HISTORIC LANDMARK COMMISSION
APPLICATION FOR A PERMIT WITHIN A NATIONAL REGISTER HISTORIC DISTRICT
JANUARY 25, 2021
HR-20-182491
724 PATTERSON AVENUE
OLD WEST AUSTIN HISTORIC DISTRICT

Construct an addition to the side of a contributing house.

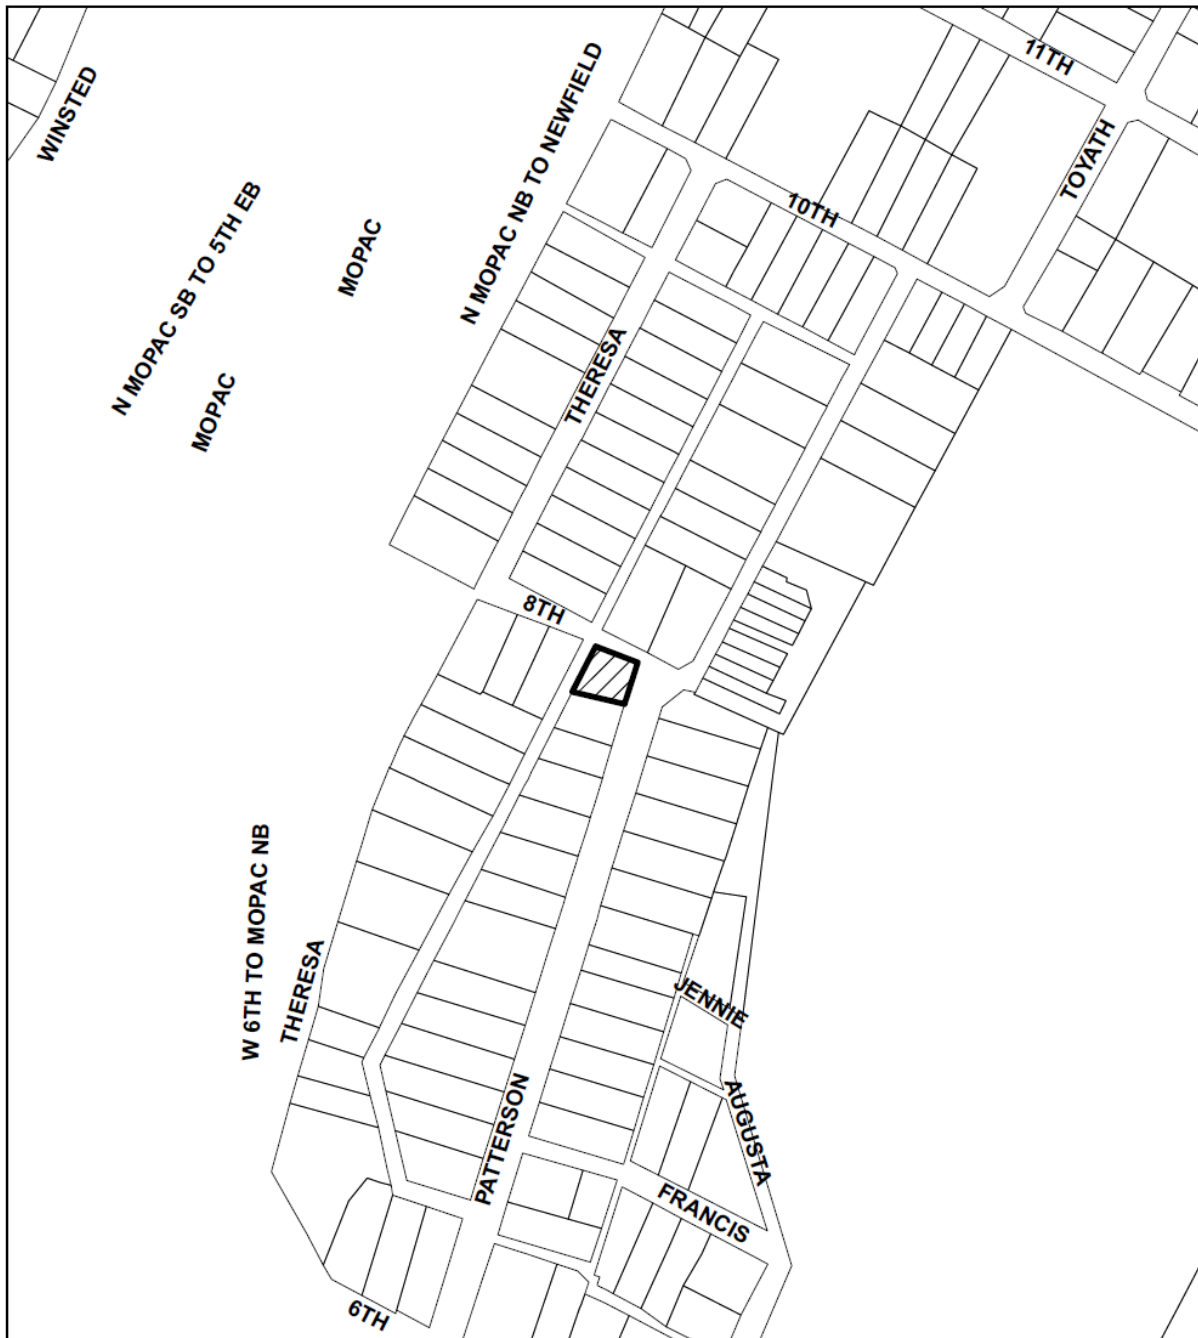
The proposed addition is set 24 feet back from the front wall of the house and has a different pattern of siding. The roof is side-gabled, in contrast to the front-gabled roof of the house and is compatible in terms of size, scale, massing, and materials.

The proposed addition will require the removal of a minimum of historic fabric, as its connection to the house is via a narrow section that will not impact the integrity or the context of the house.

The committee felt that the blank wall on the front of the addition could be distracting and should have a window to make it more compatible with the bungalow form of the house; the committee members also felt that the existing porch stairs should be retained in place so that the traditional means of entry to the house is maintained in accordance with its bungalow form.

Staff concurs with the statements and advice of the Committee and recommends approval of the project, but encourages that applicant to consider a window in the front of the addition and retaining the porch stairs.
